PCN/22/018/C+N - US

Product Range: Han HPR

Title: Change Han 34HPR EasyCon angled hood cover

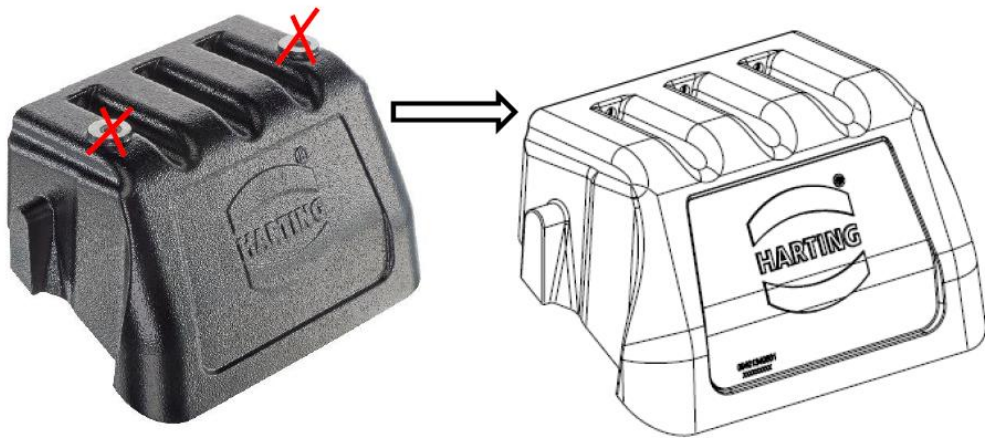
1. Concerned Part Numbers
09401340601
2. Description of Changes/News
<p>See below removal of the 2 threaded holes utilized for connection of external PE wire.</p> <div style="text-align: center;">  </div> <p>Additional Information: In the case that two external screw connections are needed, we have a new part number for such a variant – 09401340602.</p>
3. Impact on Product Specification
The technical and quality characteristics are not affected by this change.
4. Scheduled Date of Implementation
04/14/2023
5. Identification of Change
New revision level
